UNITED STATES
NUCLEAR REGULATORY COMMISSION
WASHINGTON, D. C. 20555

The Commission has issued the enclosed Amendments Nos. 108, 108, and 105 for Licenses Nos. DPR-38, DPR-47 and DPR-55 for the Oconee Nuclear Station, Units Nos. 1, 2 and 3. These amendments consist of changes to the Station's common Technical Specifications (TSs) in response to your request dated March 8, 1982.

These amendments revise the TSs to reinstate the heatup and cooldown curves for Unit 1 which had been revised by License Amendments Nos. 107, 107 and 104 which were issued on February 22, 1982.

ATTACHMENT TO LICENSE AMENDMENTS

Figure 3.1.2-1A

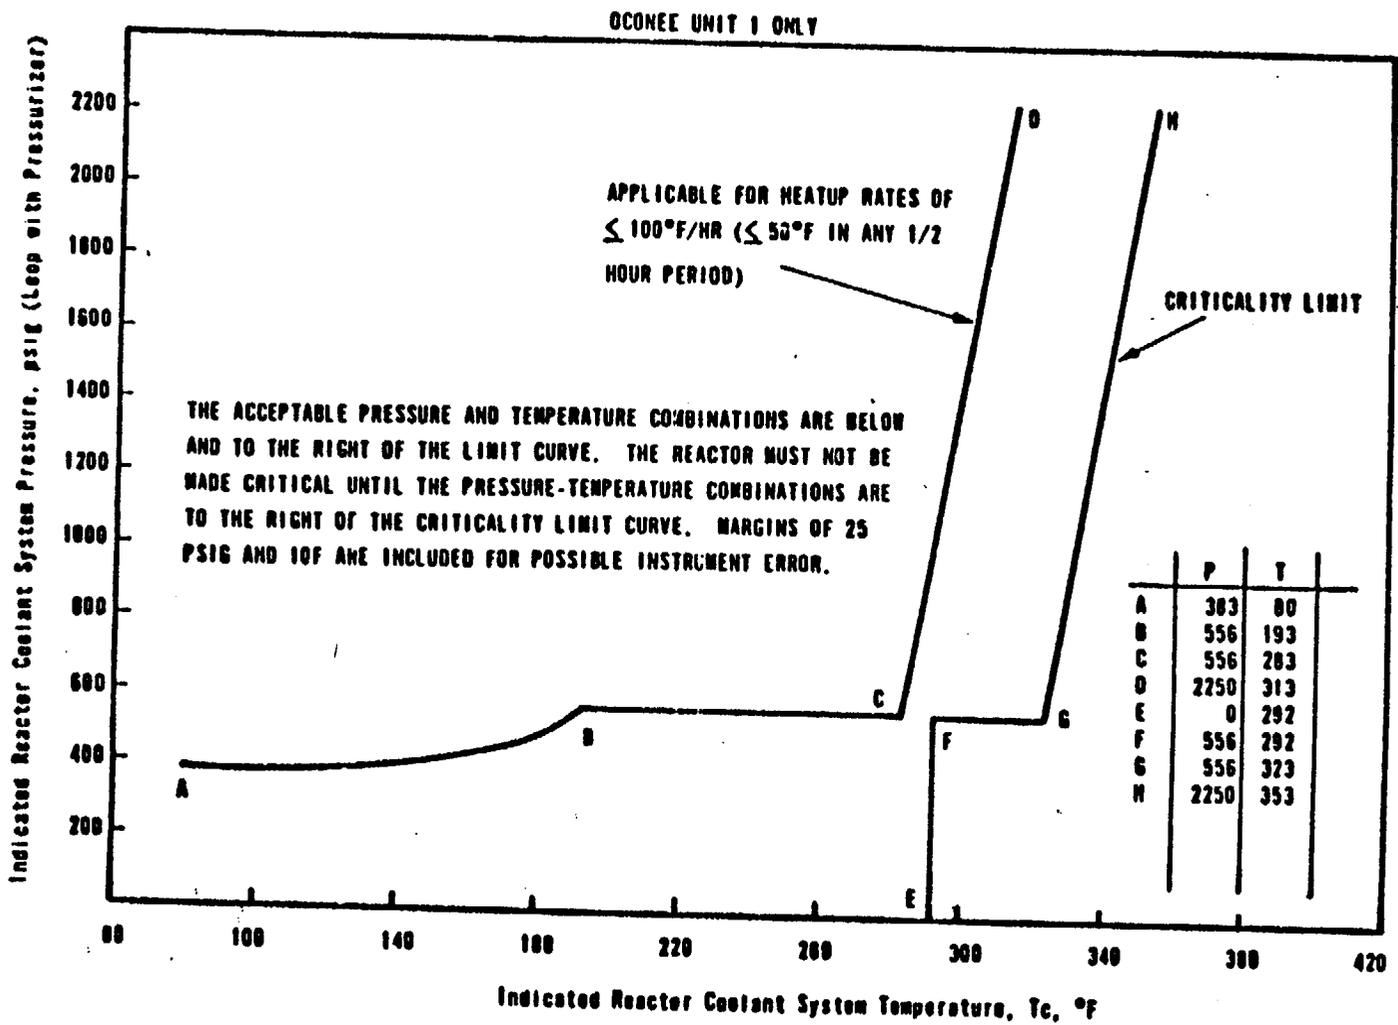
On March 5, 1982, representatives of Duke Power Company (Duke or the licensee) informed the NRC Project Manager that an administrative error had been made on the heatup and cooldown curves which had been submitted by letter dated January 12, 1982, and subsequently approved by License Amendments 107, 107 and 104 issued on February 22, 1982, for the Oconee Nuclear Station, Units 1, 2 and 3, respectively. The error involves not allowing sufficient pressure at lower temperatures (below approximately 200°F) to operate the Unit 1 Reactor Coolant Pumps (RCPs). Apparently, when the curves for all three Units were developed, the fact that the Unit 1 RCPs are different than those in Units 2 and 3 and require a high net positive suction head (NPSH) was not adequately considered. Accordingly, NRC's review and approval of the proposed curves did not consider the operational viability but only the safety aspects. Since we determined that the proposed curves represented a conservative mode of operation, we found them acceptable. In order to allow Unit 1 to operate the RCPs during heatup and cooldown at lower temperatures, a change to the curves, in the form of a license amendment, is needed. Duke was informed of this and decided to request the reinstatement of the curves, which had been superceded by the above-mentioned License Amendments, for Unit 1 for the interim and to propose the technical adjustments that are necessary to allow long-term operation in the near future. By letter dated March 8, 1982, Duke submitted the request that the original curves be reinstated.

Duke's request to reinstate the heatup and cooldown curves for Oconee Unit 1 has been reviewed and determined to be little more than an administrative change to the TSSs. The heatup and cooldown curves for normal operation of Oconee Unit 1 were approved by License Amendments 71, 71 and 68, which were issued on March 19, 1979, to be applicable for the first six effective full power years (EFPY) of operation. Since Oconee Unit 1 has an accumulated service life of approximately 5.1 EFPY, the curves which were superceded by more conservative replacements are still valid and sufficiently conservative for the remainder of the first six EFPY.

These amendments revise the common TSs to reinstate the heatup and cooldown curves for Unit 1 which had been revised by License Amendments 107, 107 and 104 which were issued on February 22, 1982.
